STAFF REPORT

TO: Planning Commission
FROM: Ben Hetzel, Lake Elmo City Planner
AGENDA ITEM: Upper 33rd Street N Conditional Use Permit Request
REVIEWED BY: Sophia Jensen, Code Enforcement Official

Re: Upper 33rd Street North Townhouse CUP
Site Plan review
PID 1302921320052 & 1302921320051

SITE PLAN

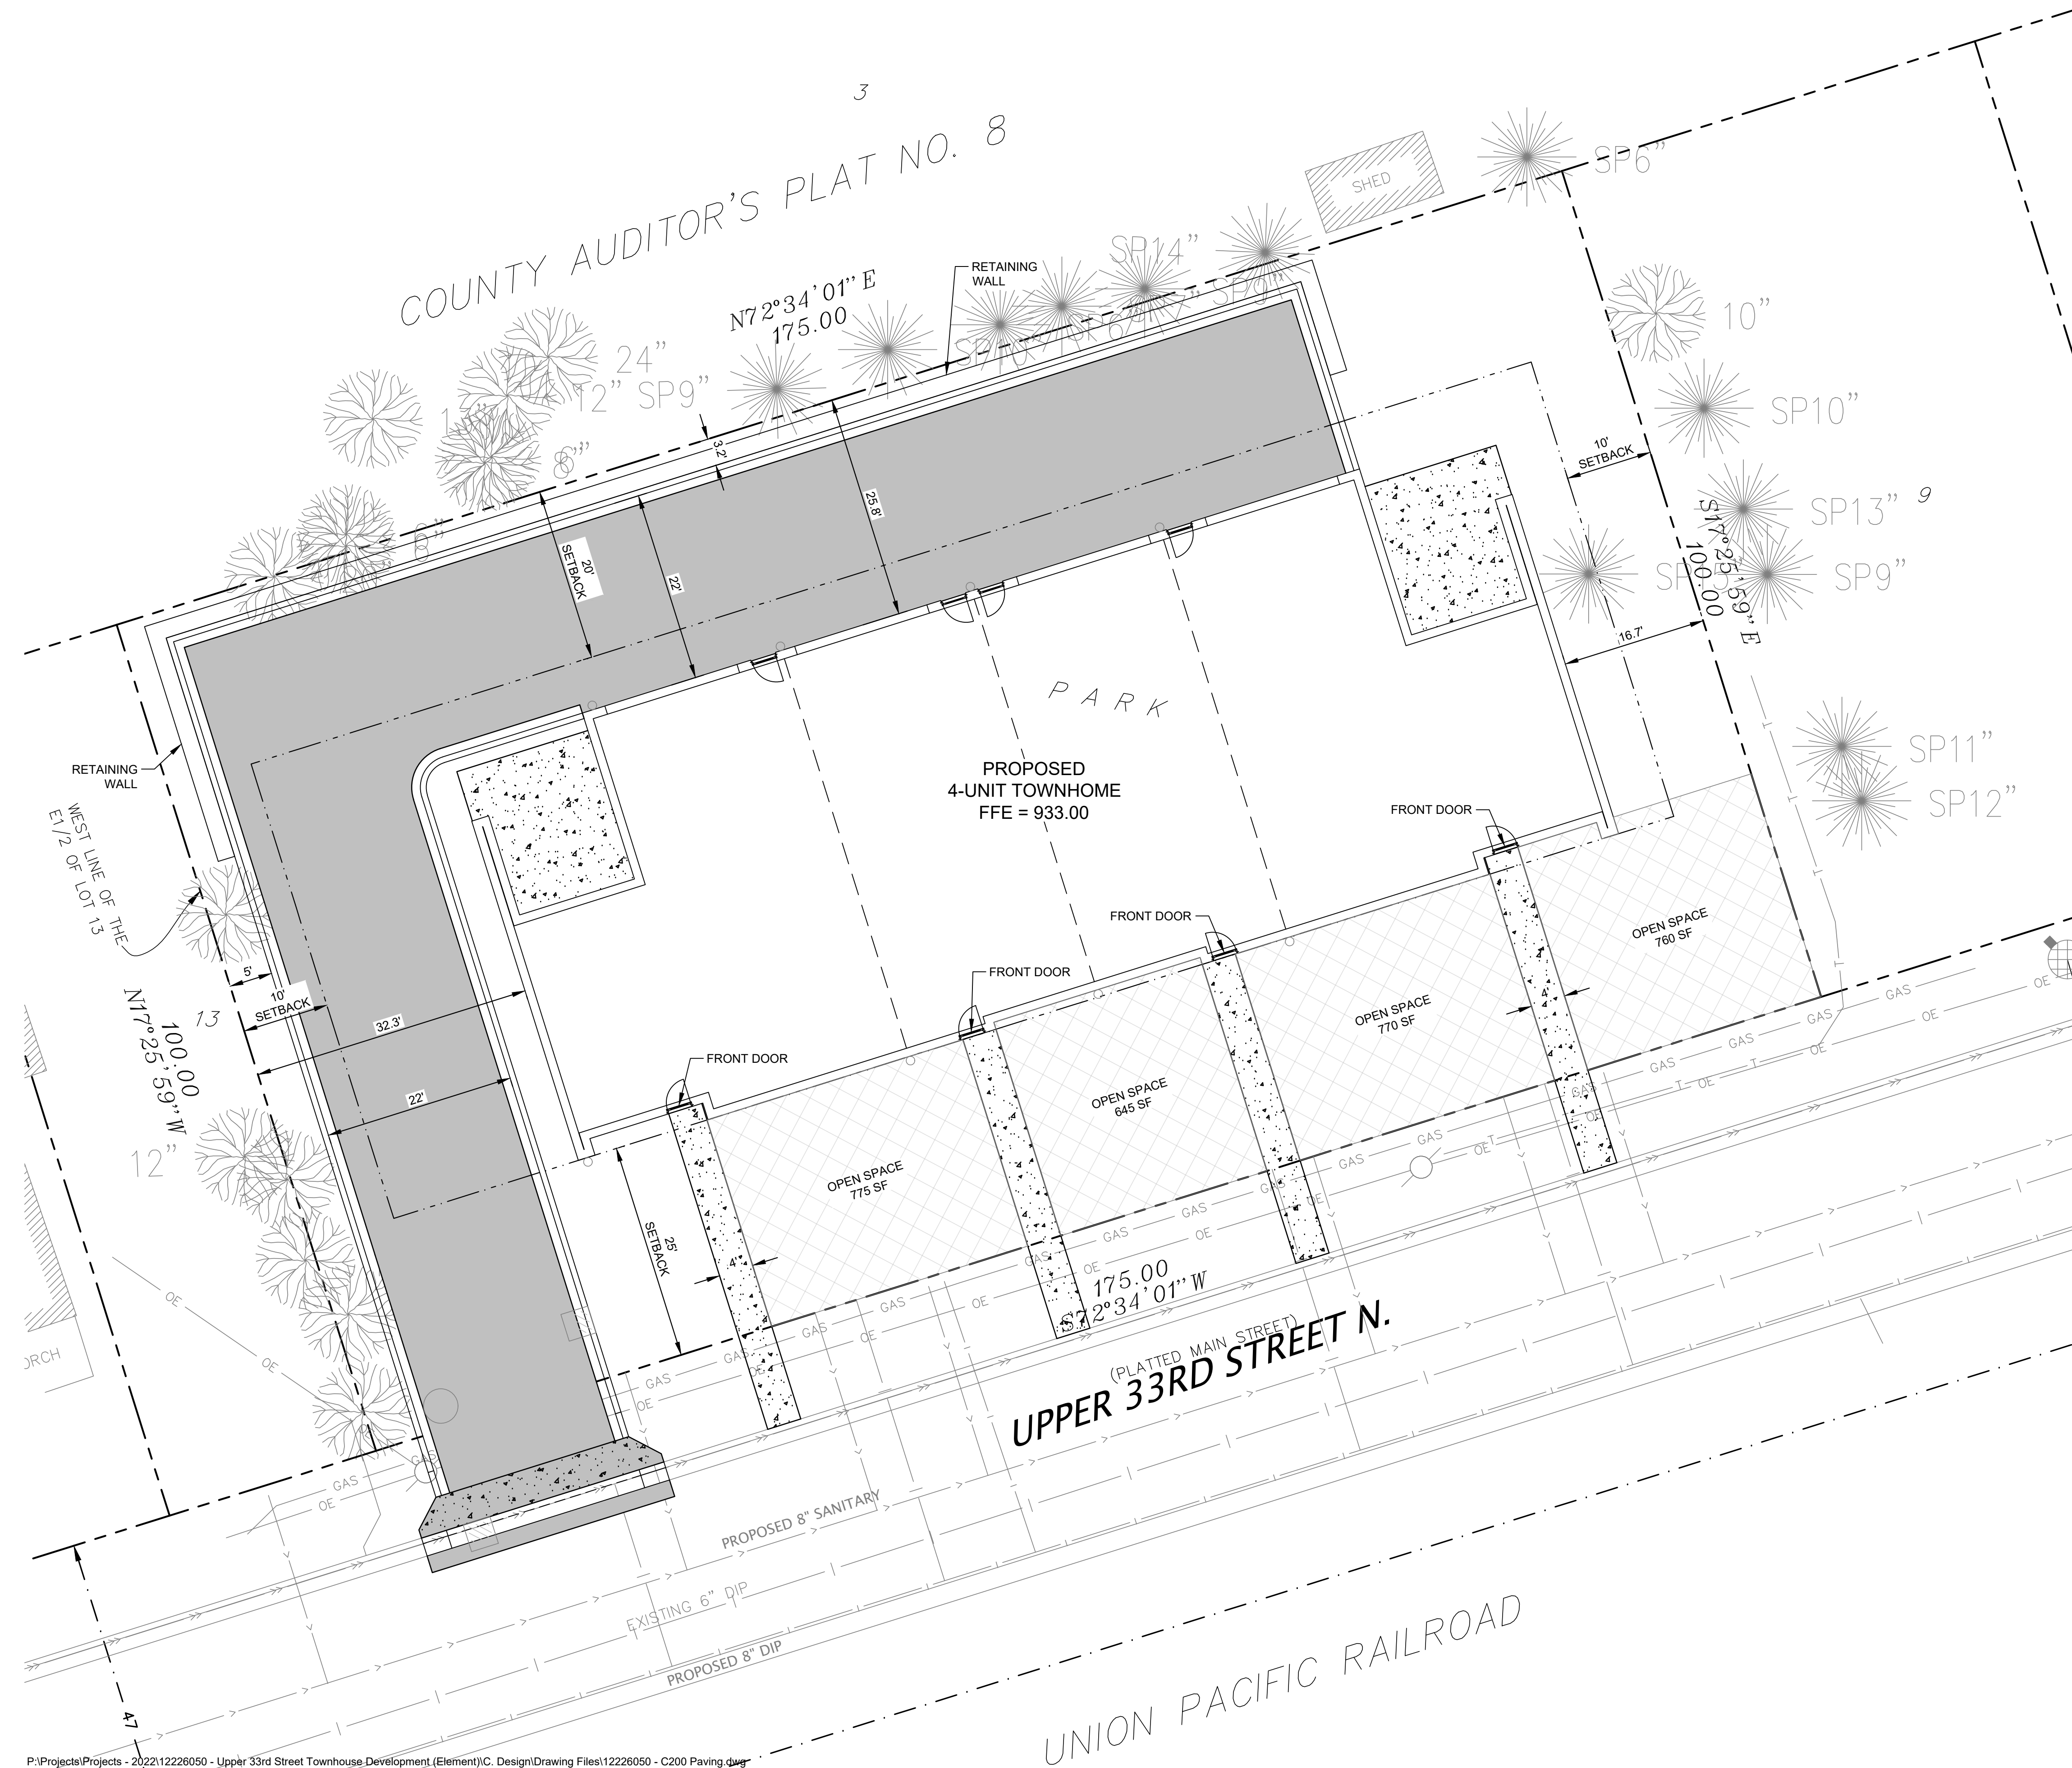
The applicant is proposing a retaining wall that abuts the west and north property lines. According to Section 105.12.200 of the Lake Elmo City Code, walls six feet in height or less may encroach into side and rear yard setbacks. However, the City Engineer has indicated that the applicant must establish drainage and utility easements along the side and rear property lines. The retaining wall and portion of driveway may not encroach within these easements. The applicant will be required to provide updated plans showing the requested easements and that they are free of encroachments.

The Lake Elmo City Code does have a provision to waive the parking requirements in the VMX zoning district recognizing the availability of on-street and shared parking facilities. Due to the inability to park along Upper 33rd Street N, staff does not recommend waiving the parking requirements for this proposal. The applicant should be required to revise the plans to show adequate visitor parking spaces.

6. The proposed retaining walls along the west and rear property lines should be a minimum of 5 ft from property lines and outside all lot easements.
7. Revise the existing conditions plan to show a minimum distance of 150 ft outside the property boundary in all directions.

7. The Site plan shows retaining walls along part of the west property line and most of the rear property line. The retaining walls should be a minimum of 5 ft from the property lines and outside of all lot easements, including retaining wall footings.

UTILITY PLAN
 Sheet: **C400**

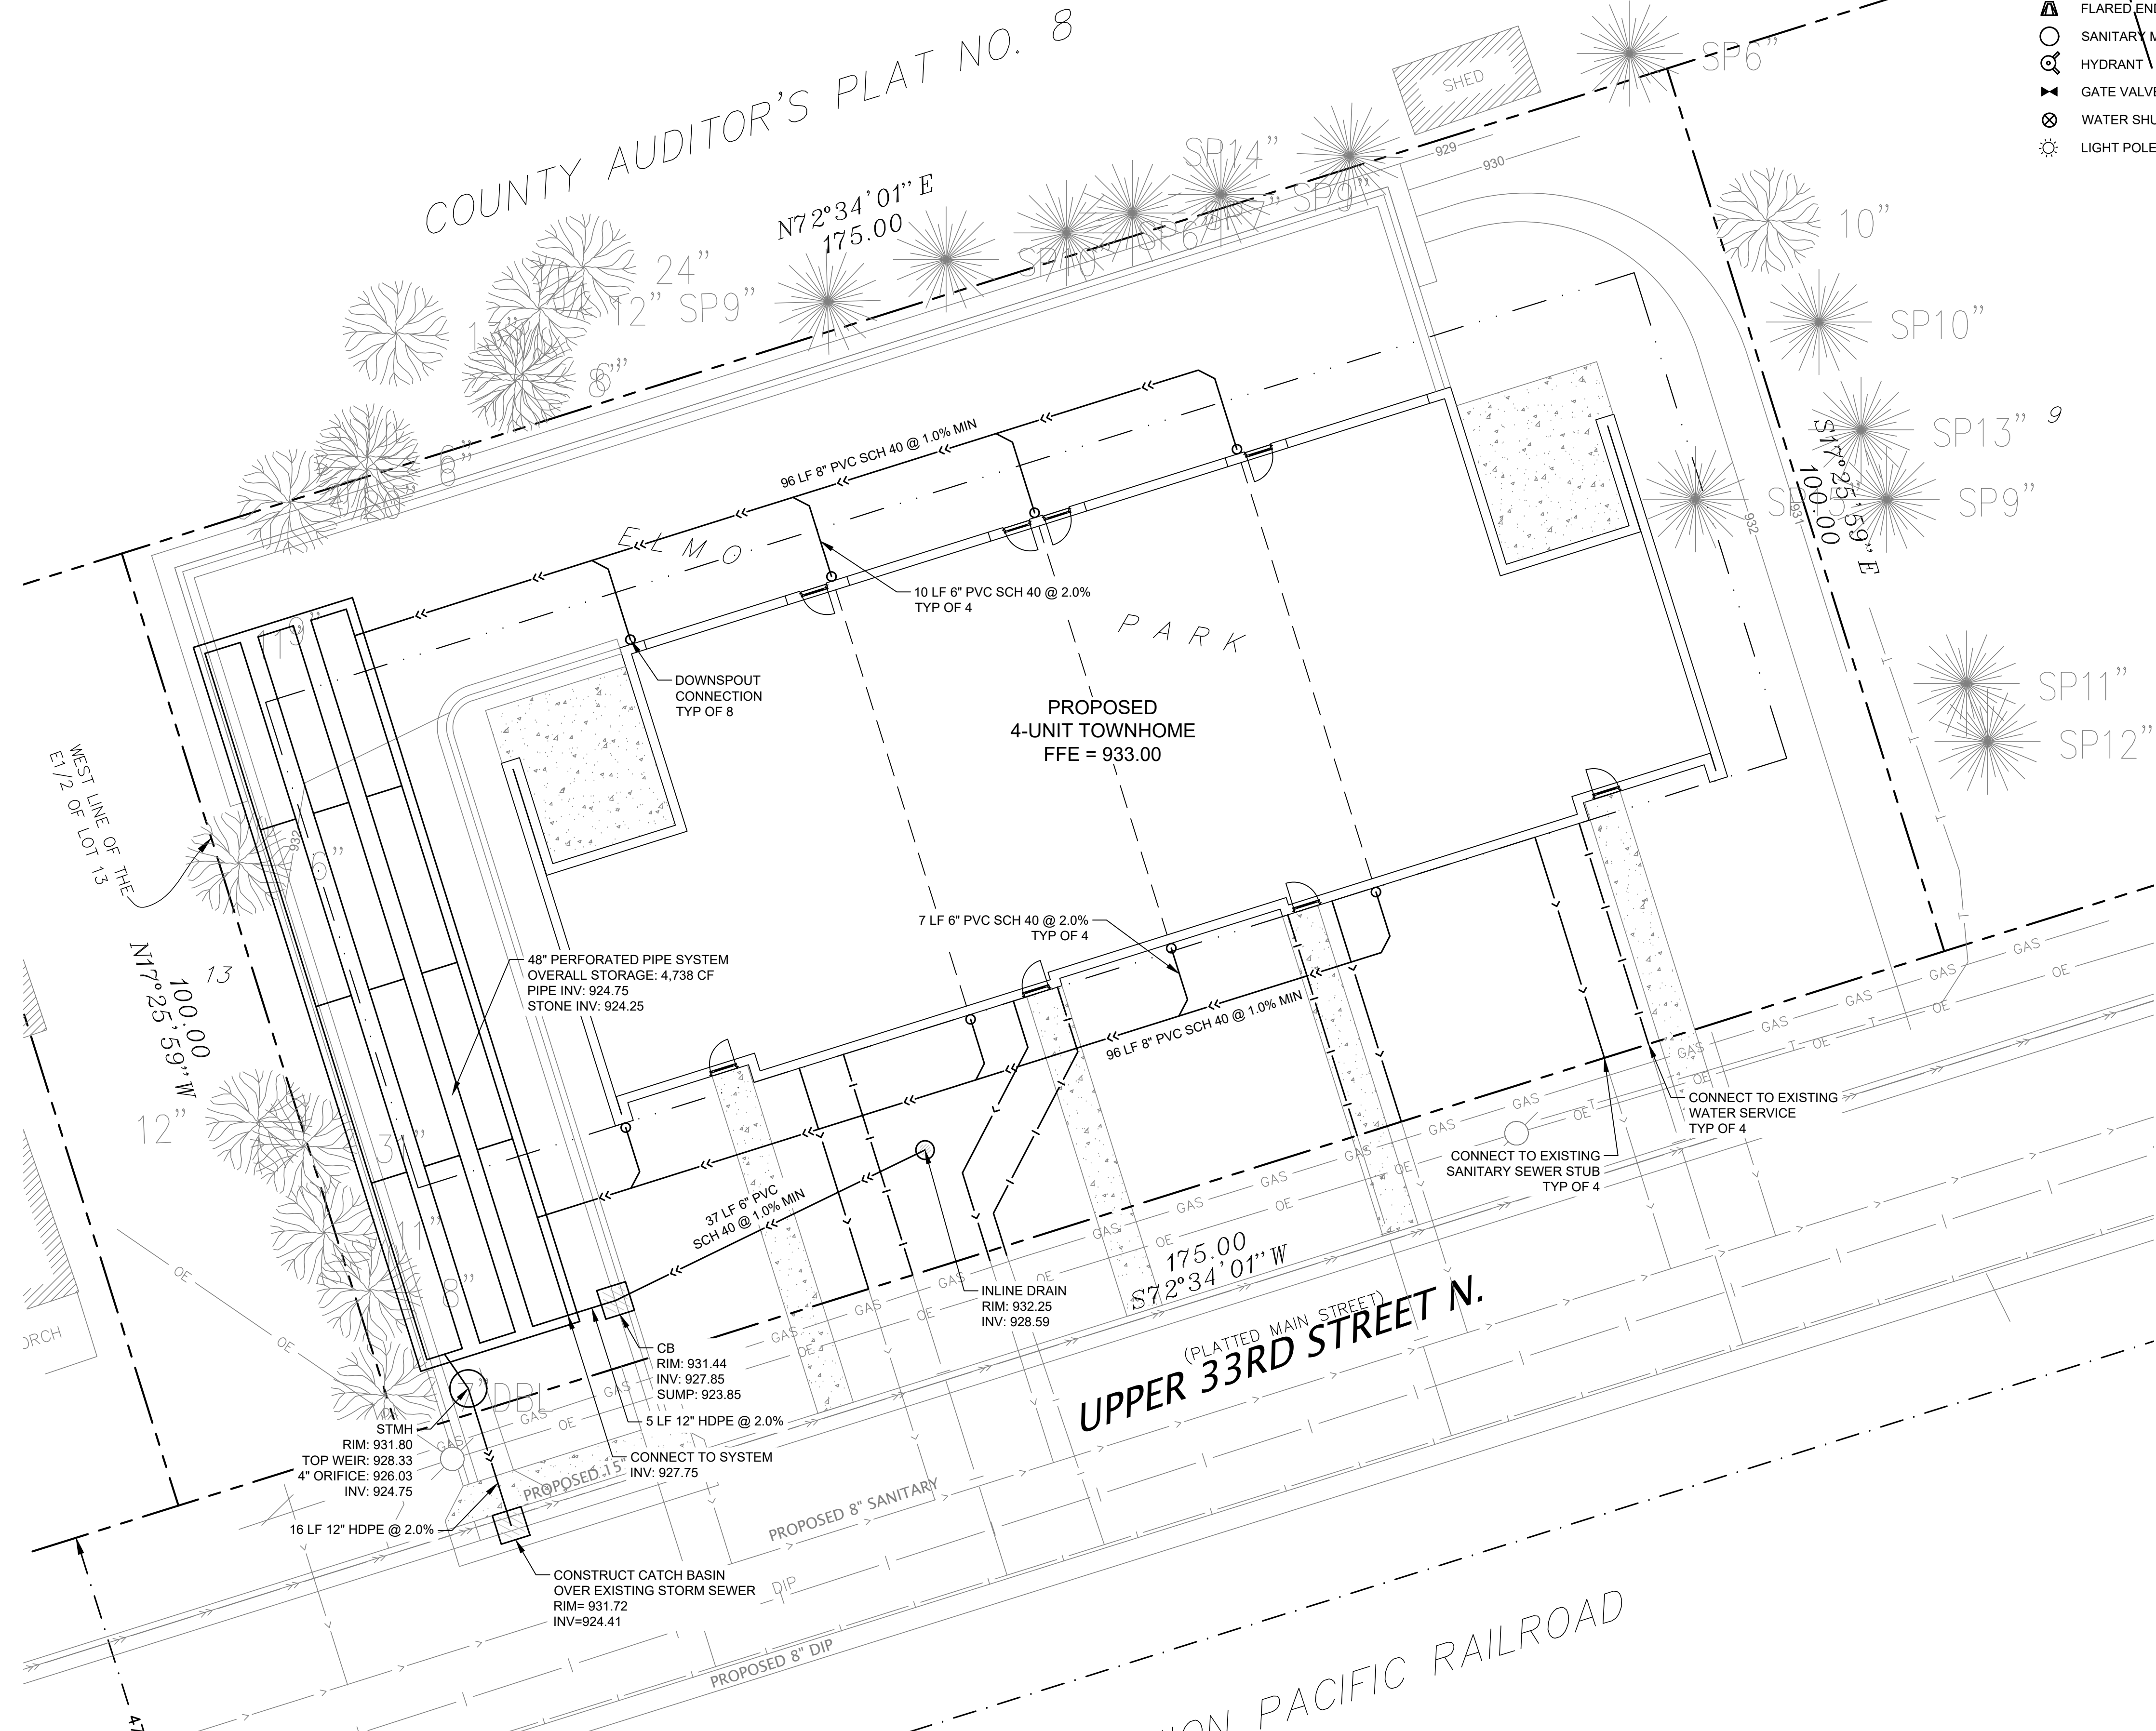
10. The proposed stormwater management plan proposes an underground storm water infiltration chamber to mitigate 100% of the required rate and volume control. The infiltration chamber outfall pipe is proposed to connect directly to the existing storm sewer along Upper 33rd Street, thereby redirecting the existing site runoff from discharging to the north, and discharging the proposed condition runoff to the south. No storm sewer calculations have been provided to demonstrate available capacity in the city storm sewer system at this location.

13. Municipal water supply is available to the site. There are four (4) existing water service stubs available along the frontage of the property to provide an individual water service connection for each townhome. Connections to existing public watermain will be required, including all connection and permit fees.

14. Sanitary sewer service is available to the site. There are four (4) existing sanitary sewer service stubs available along the frontage of the property to provide an individual sewer service connection for each townhome. Connections to existing sewer will be required, including all connection and permit fees.
